### STAFF REPORT

### SPECIAL PERMIT AMENDMENT APPLICATION NO. SPA 2004-LE-053

Trustees of the Lighthouse Baptist Church

Group 3—Amend SP 2004-LE-053 previously approved for a church to permit the addition of a

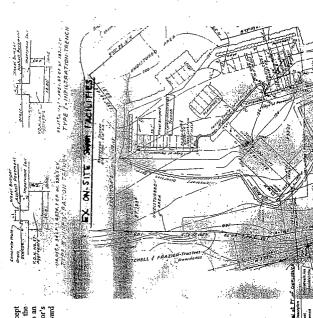
1. Comment: It remains unclear how the transitional screening requirements of ZO 13-303.3 A.(1)-A.(3) have been addressed as the square feet of canopy for individual trees and the transitional screening calculations demonstrating how the transitional screening requirements will be met have not been provided.

Recommendation: Calculations should be provided that show the square feet of canopy for both the existing and proposed trees and how the total square feet of these trees meets or exceeds the requirements set forth in ZO 13-303.3 A.(1)-A.(3).
